# CITY of NOVI CITY COUNCIL

**SUBJECT:** Consideration of Zoning Map Amendment 18.682 with Planned Rezoning Overlay (PRO) SP08-09A from the applicant, J.S. Evangelista, LLC, to rezone property located at the southwest corner of Fourteen Mile and Novi Roads from RA, Residential Acreage with a Planned Unit Development (PUD) to RM-1, Low-Density, Low Rise, Multiple-Family Residential, favorable consideration of the PRO Concept Plan, and revocation of the right to develop under the existing Maples of Novi PUD. The subject property is 3.88 net acres.

# PLAN REVIEW CENTER REPORT

MAPLE MANOR of NOVI  
Concept Elevations

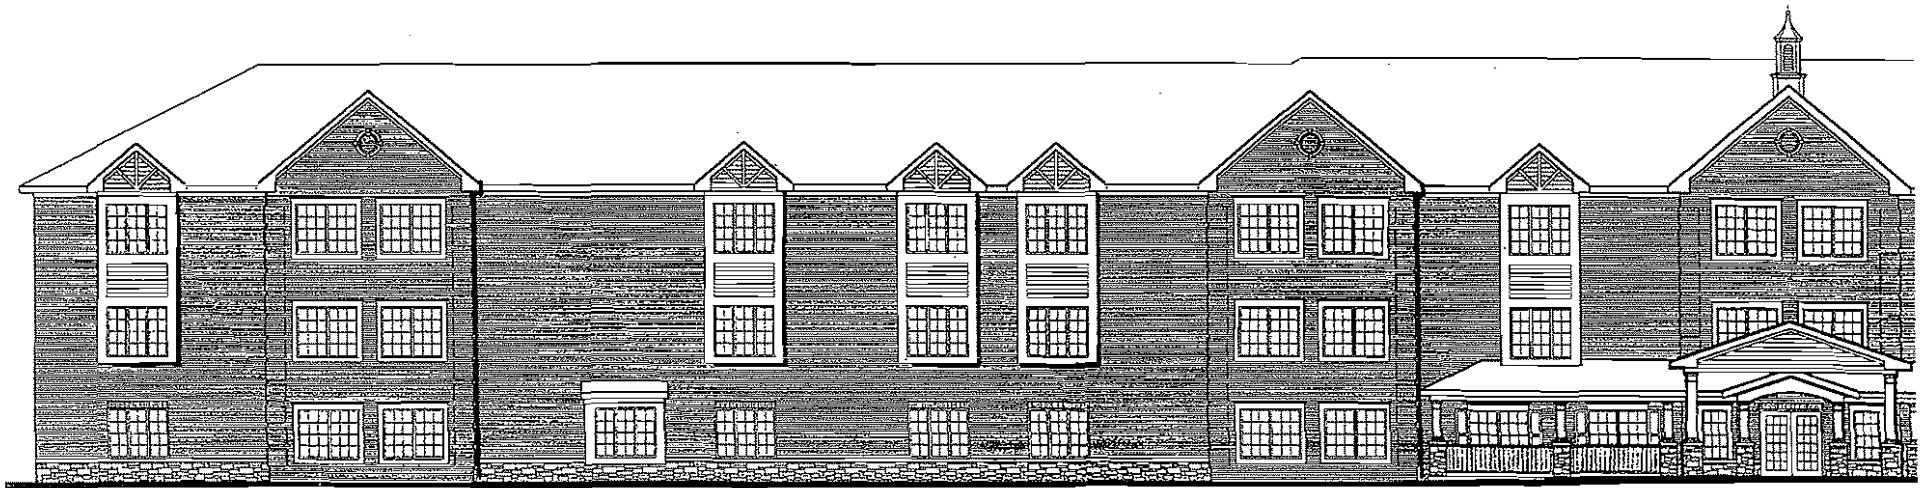
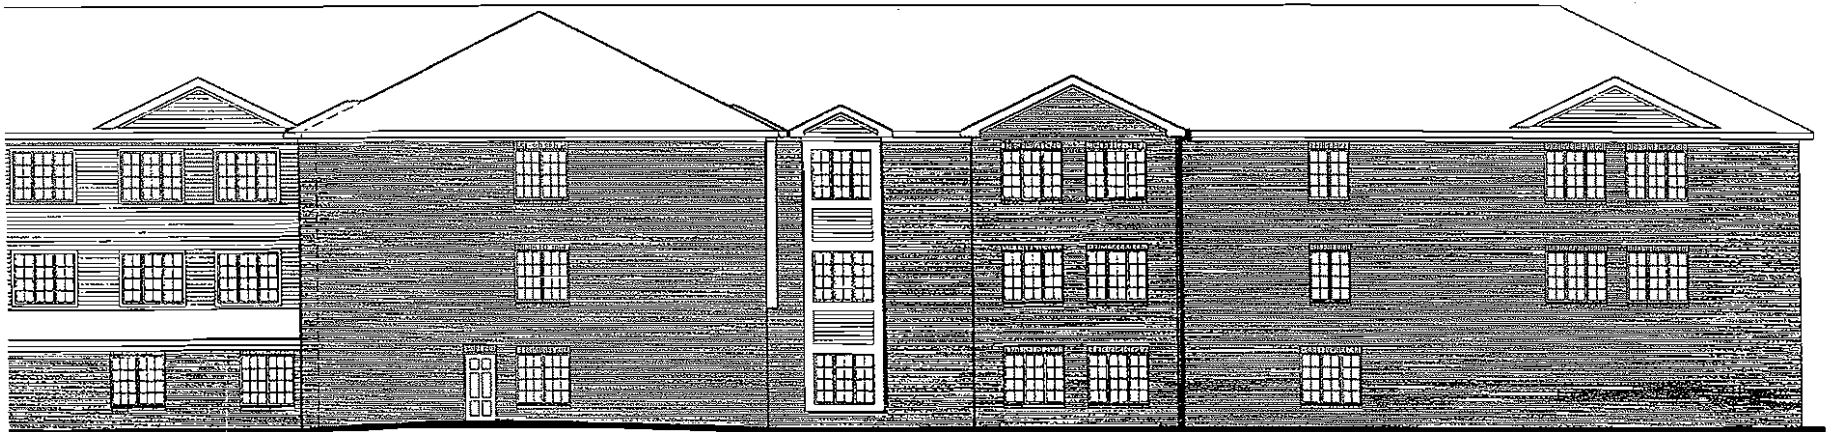
The Façade Consultant recommended changes to reduce the impact of the asphalt shingles. He recommended approval of the Section 9 Waiver if the Applicant revises the rear elevation to be more consistent with the front elevation. The Applicant submitted modifications to the façades and they were distributed to the Planning Commission. The Façade Consultant asked for increased peaks that protrude into the shingles, and perhaps some relief into the façade that would better highlight the building.
